Re: Pre-Application Review - Bannister Creek Estates Subdivision
Legal: 35-06-09-DD, Tax Lot 100
Situs: 1951 Russell Road

BANNISTER CREEK ESTATES

RE: BANNISTER CREEK COMMENTS AND CONDITIONS: 35-06-09.DD/100

PRE-APPLICATION TENTATIVE PLAN
C1.0

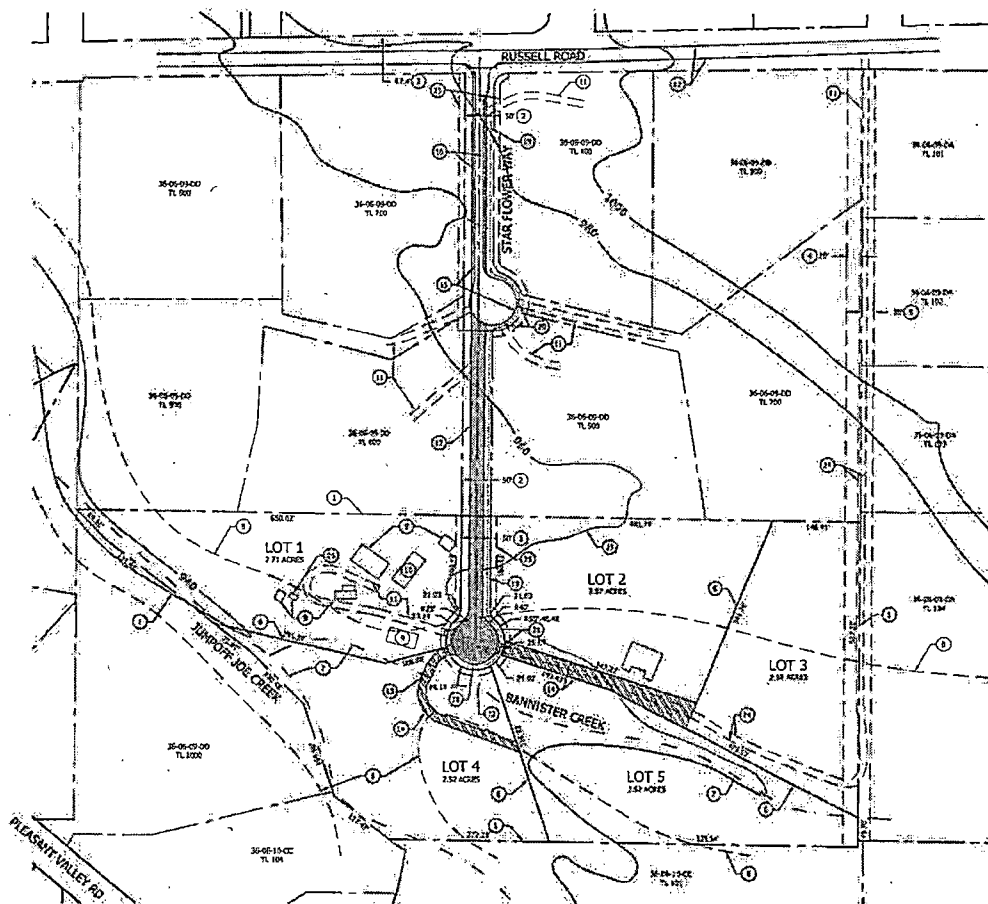
- 1) Prior to Tentative Plan approval, the Applicant shall prepare a detailed flood study including floodway delineation for the approximate A Zone of Bannister Creek and obtain a Let of Map Revision (LOMR) from FEMA [44.CFR 65.3. Applicant shall submit an encroachment certification ("no-rise") certifying no adverse impact to the SFHA. [44 CFR 60.3(d), 44 CFR 60.3(c)(10)].

- 2) Prior to Tentative Plan approval, the Applicant shall submit SFHA information including BFE data on the Tentative Plan for Bannister Creek and Jumpoff Joe Creek. [44 CFR 60.3(b)(3)]. All new road construction shall be elevated above the 100-year SFHA.

- 3) Prior to Tentative Plan approval, the applicant shall submit preliminary plans showing the approximate grades of all streets proposed and/or existing in the land division, and the approximate widths and locations of any proposed easements for cut fill slopes, drainage, and public utilities. [50.060.P]

- 4) Prior to Tentative Plan approval, the applicant shall submit typical cross sections at 50-foot intervals of proposed streets, showing the location of all proposed utility improvements within the street right of way and adjacent easements at a scale which will clearly show the details. [50.060.Q]

- 5) Prior to Tentative Plan approval, the Tentative Plan shall identify the classification of Starflower Way as Rural Residential. The submitted Tentative Plan indicates upgrading the classification of Starflower to Limited Residential. In areas where the topography is gently rising, less than 15% side slopes, the number of lots served shall be 10 or less for Limited Residential classification. The submitted Tentative Plan indicates Starflower Way providing direct access to greater than 10 lots. [11.030]

- 6) Prior to Tentative Plan approval, the applicant shall extend streets terminating with a street plug to the boundary of the subdivision where necessary to give access to a future, adjacent, land division. [81.080, 81.090]

- 7) The existing cul-de-sac on Starflower Way shall be physically removed prior to Final Plat. Re-surfacing the existing section of Starflower Way with asphalt concrete paving will be required prior to Final Plat. [81.130]
